JAMESTOWN ACTIVE TRAVEL SCHEME

Preliminary Design Report

RGW-RP-AL-0002-P02

**Stage 1/2 Road Safety Audit
Proposed Active Travel Scheme,
Jamestown, Co. Roscommon**

GENERAL ARRANGEMENT JAMESTOWN SHEET 4 OF 4

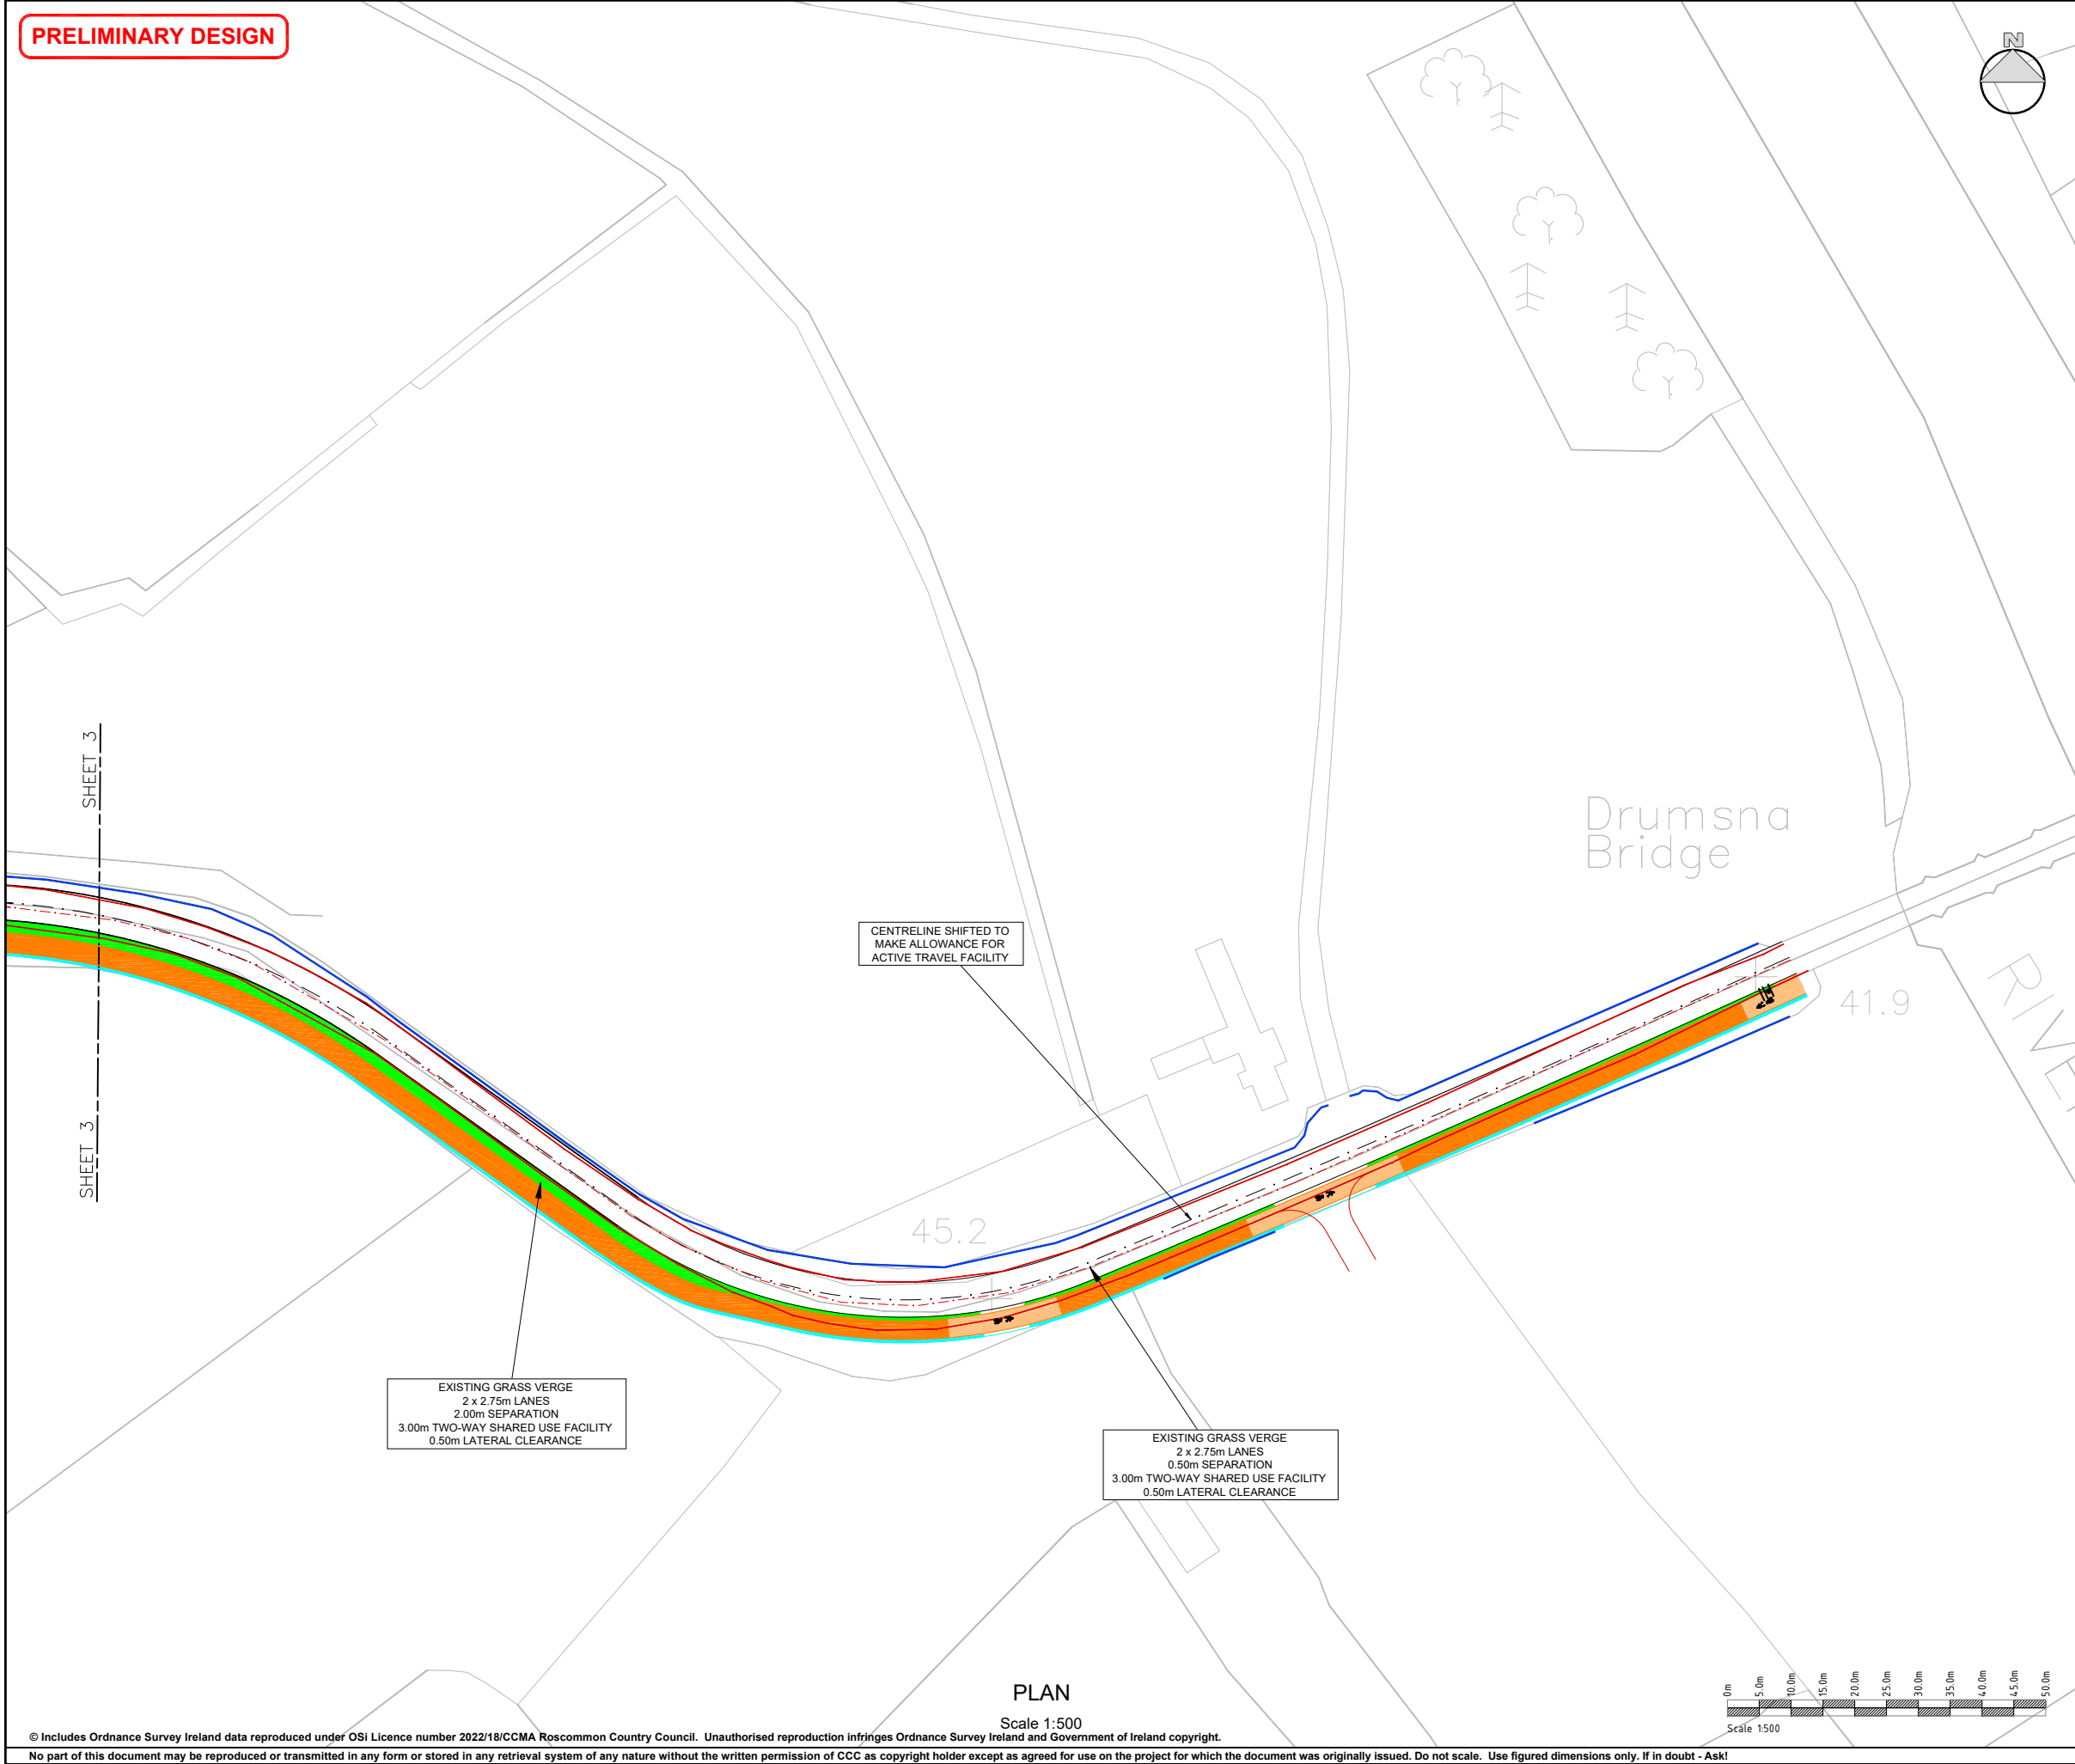
Problem No.02: Tie into Existing Infrastructure**Location: Eastern Side of Proposed Scheme - Drumsna (Drawing No. RCW-DR-GA-0004)**

The audit team note that the proposed active travel route at Drumsna appears to stop abruptly at the connection point with the existing infrastructure. This sudden termination of the shared surface raises concerns about potential trip hazards and difficulties for pedestrians and cyclists transitioning between the two surfaces. Without proper alignment and continuity, there is an increased risk of slips, trips, and falls for vulnerable road users at this location.

The design team must carefully consider the transition point where the shared surface meets the existing infrastructure at Drumsna and throughout the proposed scheme. It is essential to provide a seamless connection that ensures a safe and smooth passage for pedestrians and cyclists.

Problem No.05: Signage Positioning**Location: Eastern Side of Proposed Scheme (Drawing No. RCW-DR-GA-0004)**

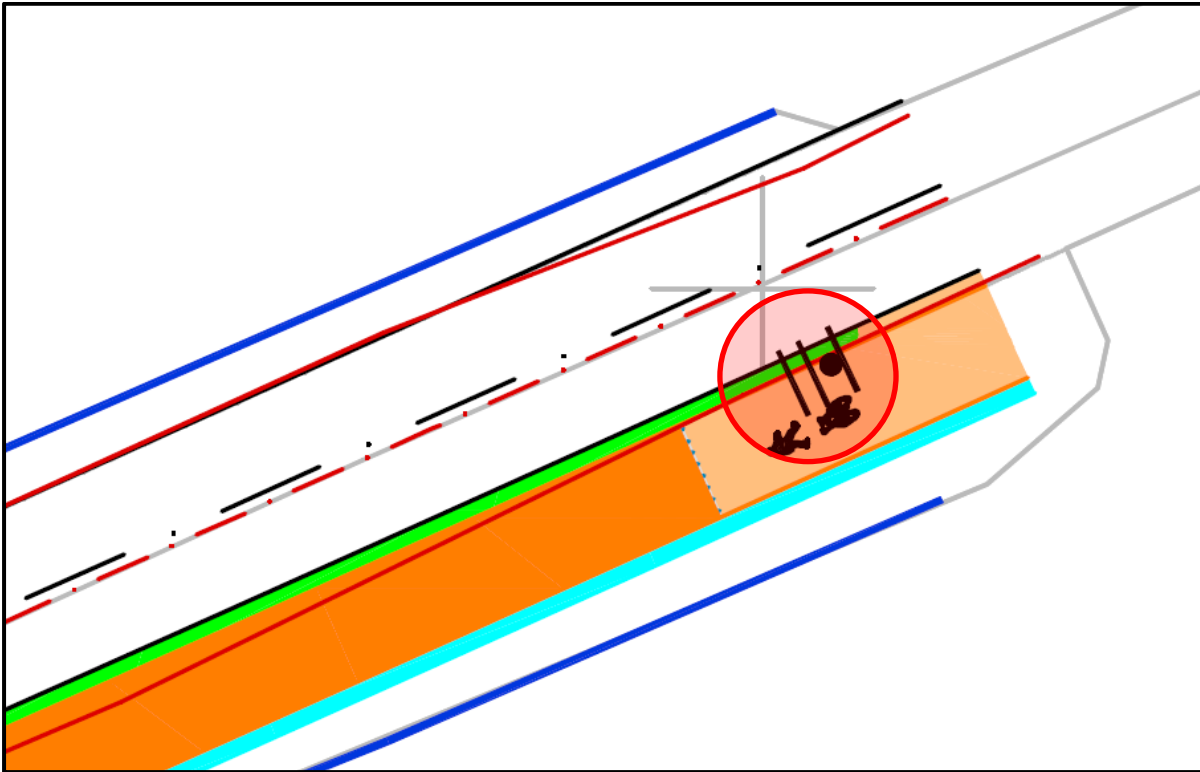
The audit team has observed from the drawings that the proposed sign location appears to be within the shared facility. This positioning could significantly hinder the smooth and safe movement of vulnerable road users along the route, particularly for visually impaired and wheelchair users, potentially causing injuries and conflicts with other users.

The design team must carefully review the proposed sign locations and ensure that they are strategically placed outside the shared facility, where they do not obstruct the path of vulnerable road users.
